TDECQ and SRS

Piers Dawe

Mellanox

1-dimensional TDECQ is only part of what we need. SRS tweaks can follow

TDECQ map (50GBASE-LR, 100GBASE-DR)

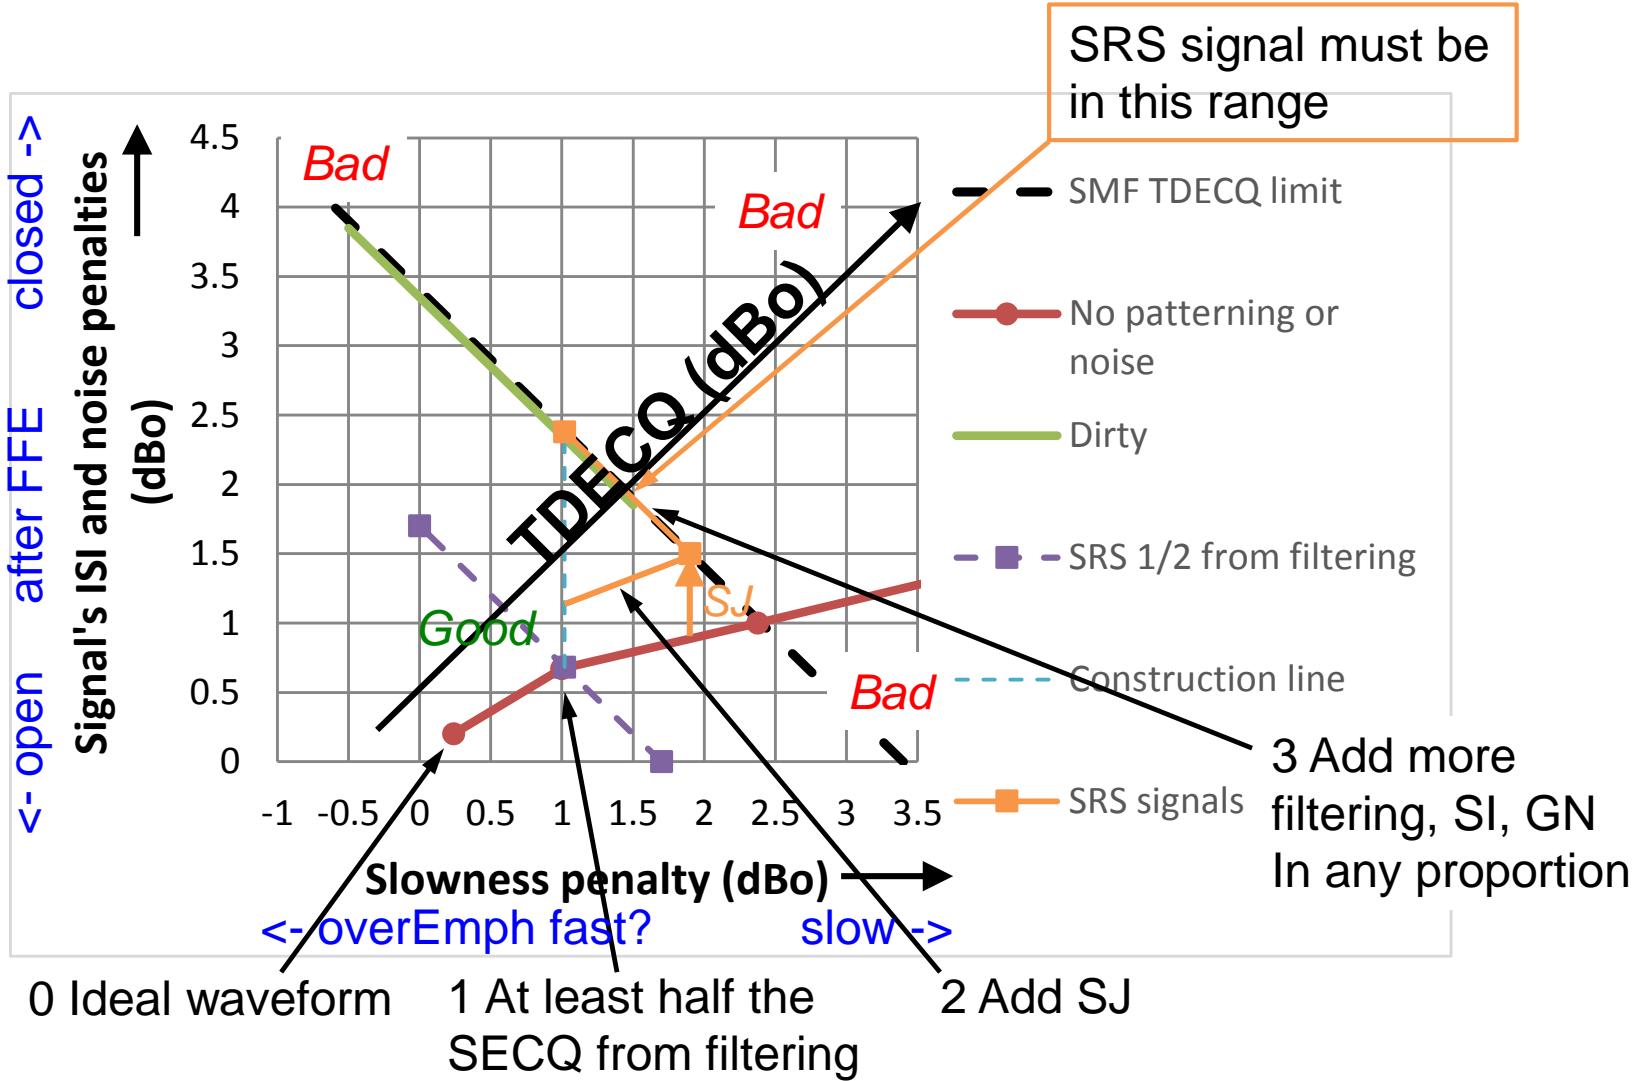
- Need to be clear where signals can be**
- ✓ Bottom: natural limit
 - ✓ Upper right: TDECQ limit
 - ✗ Right: vertex where it appears real transmitters aren't
 - ✗ Top: no limit
 - ✗ Left: no limit

TDECQ map and Rx specs

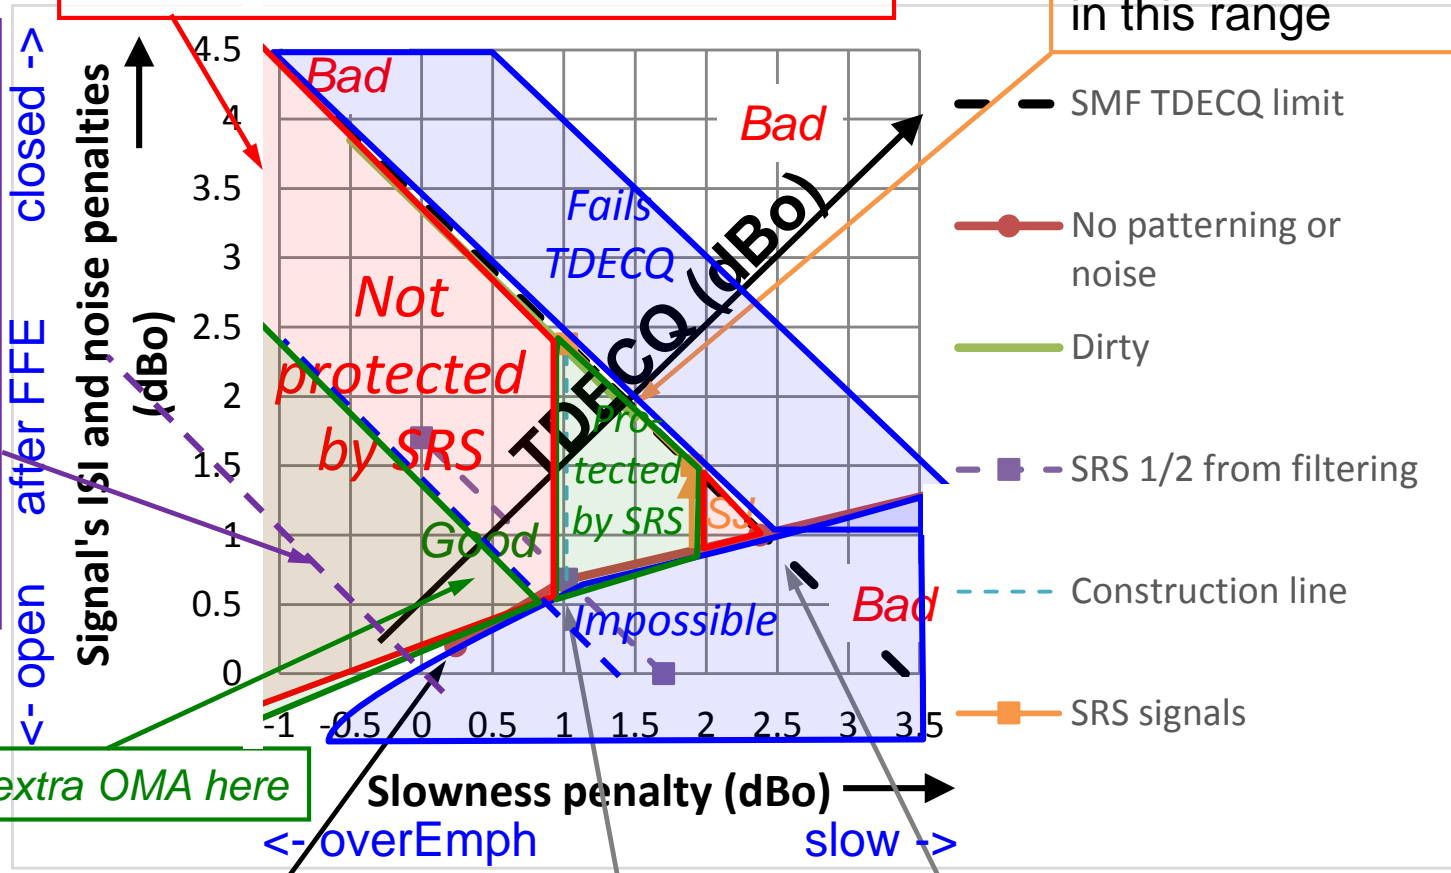
There's no limit on the left in the draft

The "other" receiver sensitivity is defined up to the max for TDECQ, with min. zero, which seems too low

Rx sees extra OMA here

Transmitted signals are allowed that receivers don't have to receive (red regions)

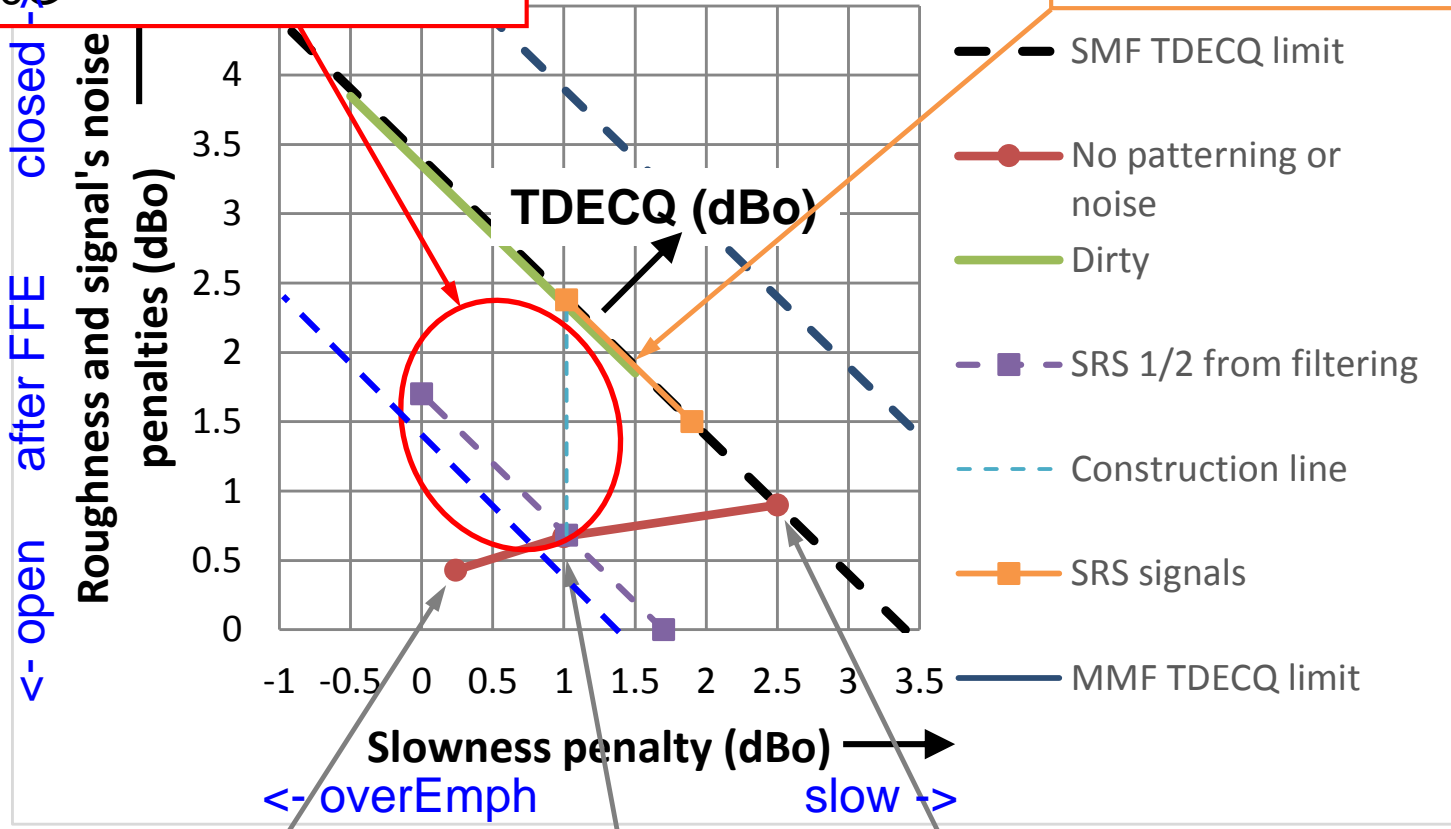
Mismatch between SRS and real signals?

Where will real poor signals be? Here? 50G can be better than 100G

Don't support unrealistic bad scenarios

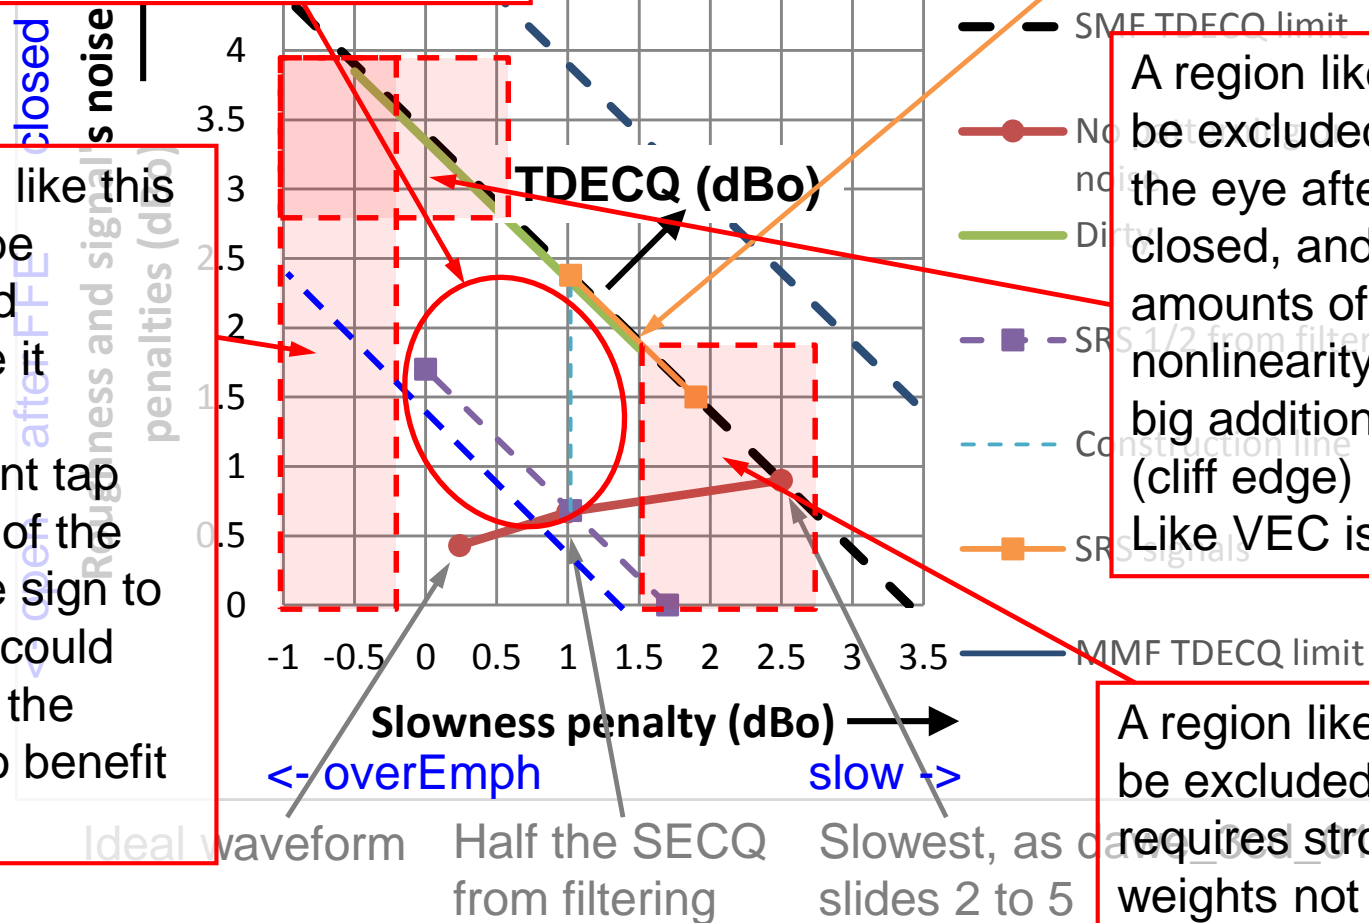
A region like this should be excluded because it requires significant tap weights of the opposite sign to normal, could confuse the CDR, no benefit to Tx

A region like this should be excluded because the eye after FFE is very closed, and small amounts of e.g. nonlinearity would cause big additional penalties (cliff edge) Like VEC issue in C2M

A region like this should be excluded because it requires strong tap weights not useful in practice, would probably have failed T/2-spaced TDECQ

"Exclusion" could be by giving signals in the red boxes worse TDECQ scores, or by "hard" pass-fail rules

Extremes of worst-case signals

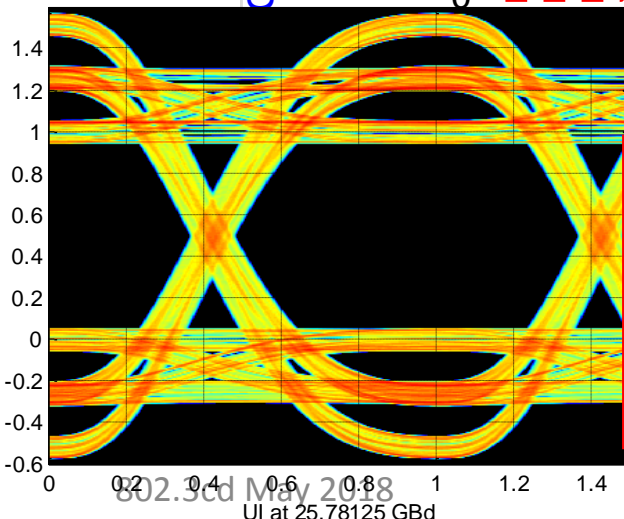
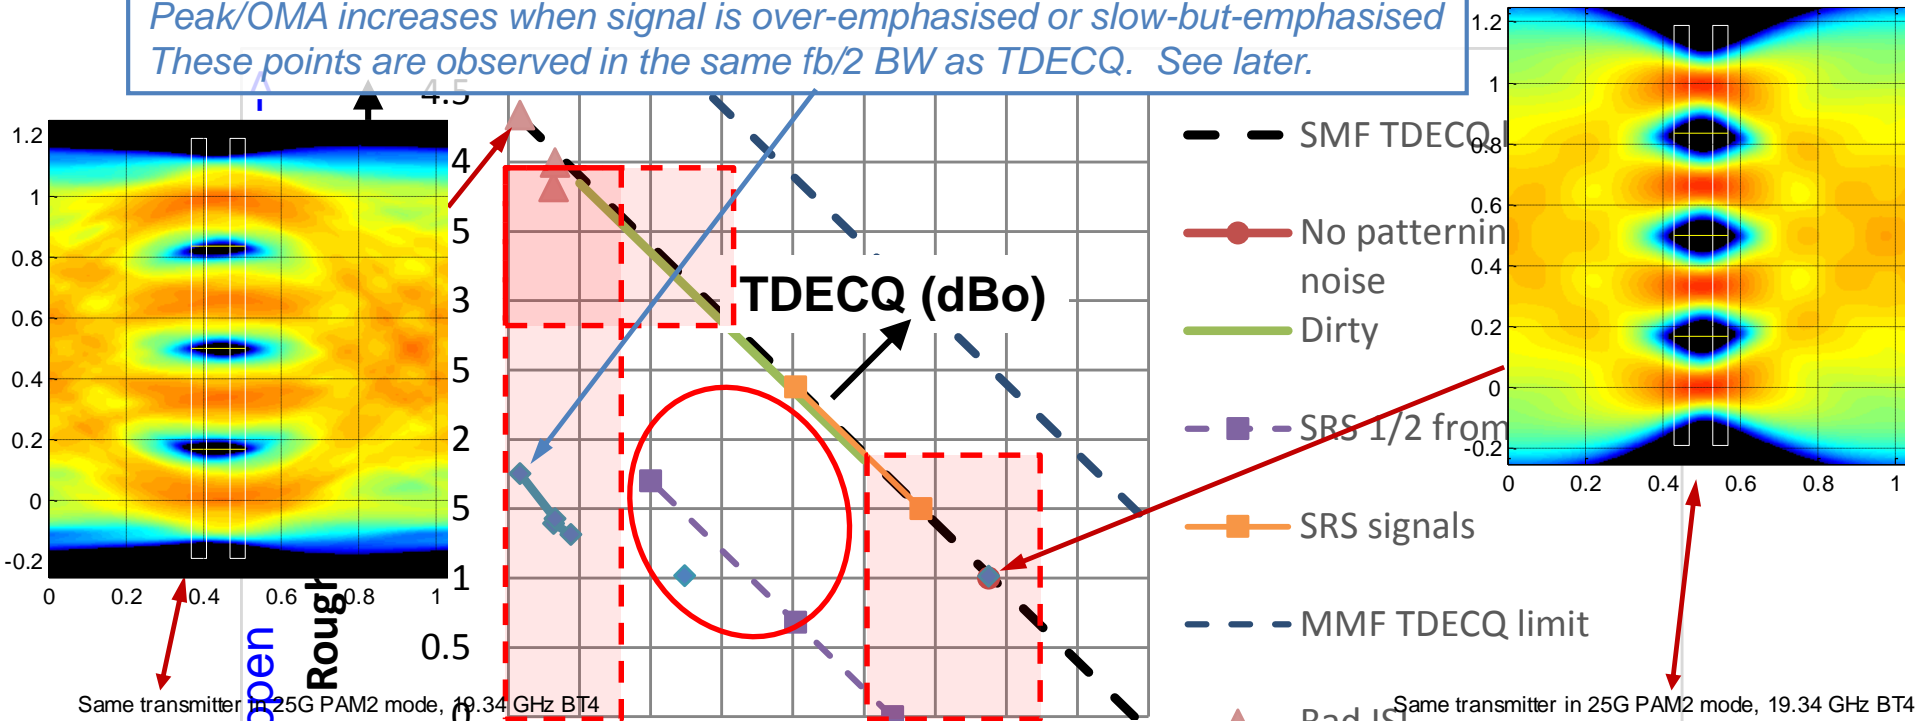
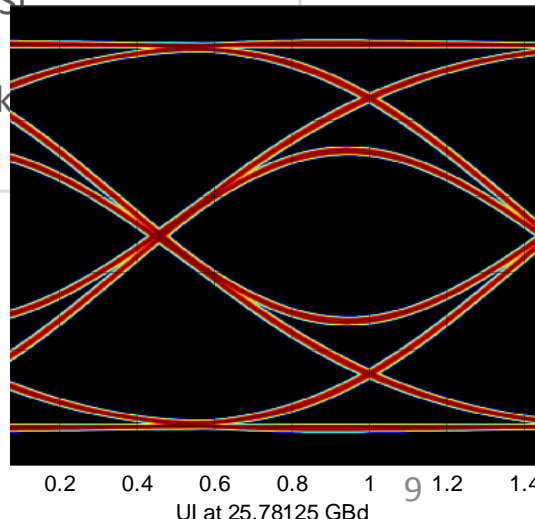
The signal on the left is bad because nothing can be done to improve it – neither sensitivity nor EQ.
 Worse is allowed by the draft
